Industry comments on ACSF-18-04

Proposal for Requirements of ACSF of Category B2 – Related to the General System Classification / Human Driver Priority / Information to the Driver

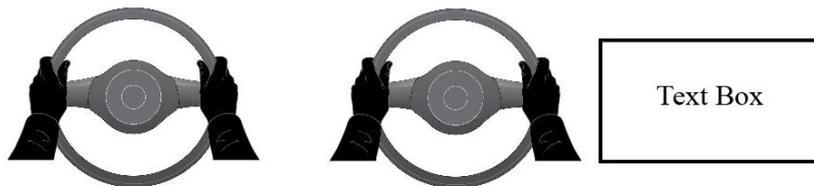
x.x.x.2.3.[TP25] The system shall provide a means of detecting that the driver is holding the steering control **after the transition period** and shall warn the driver in accordance with the warning strategy below:

If, after a period of no longer than [3 seconds] [RA(26)] after the initiation of the transition demand, the driver is not holding the steering control, an [optical] warning signal shall be provided. This signal shall be the same as the signal specified in paragraph x.x.x above.
